PREPARED FOR THE PLAN COMMISSION

Project Address: 223 South Pinckney Street (District 4- Ald. Verveer)
Application Type: Demolition Permit, Planned Development Alteration, Conditional Use, and Certified Survey Map
Legistar File ID # [55916](#), [55921](#), [56121](#), & [56288](#)
Prepared By: Kevin Firchow, AICP, Planning Division
Report includes comments from other City agencies, as noted
Reviewed By: Heather Stouder, AICP, Planning Division Director

Summary

Above: West Wilson Street - Lower Levels of Hotel
Proposed May 7, 2019 Alteration

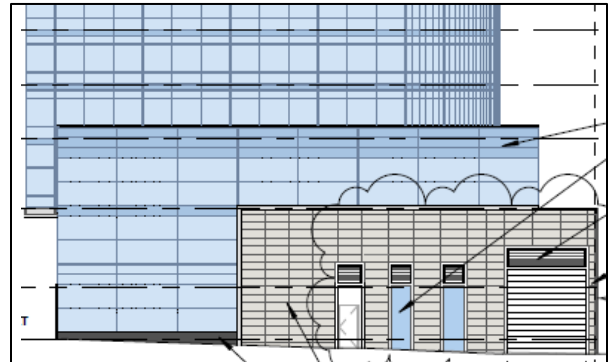
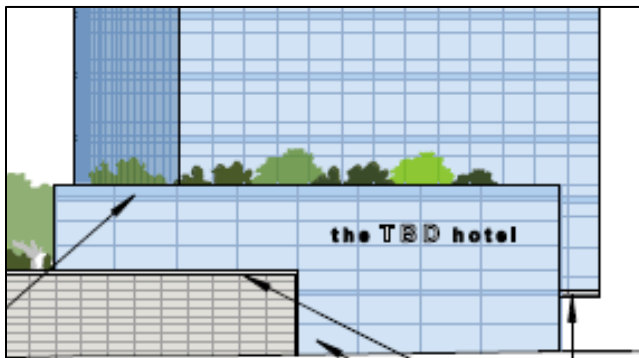
Corresponding façade changes are proposed to the East Wilson and Doty Street facades. Along Wilson Street, the previously approved underground parking entrance is now comprised of a door and spandrel-clad panels. Along Doty Street, additional windows and doors to an enclosed bike parking area are now proposed. No changes are proposed along South Pinckney Street.
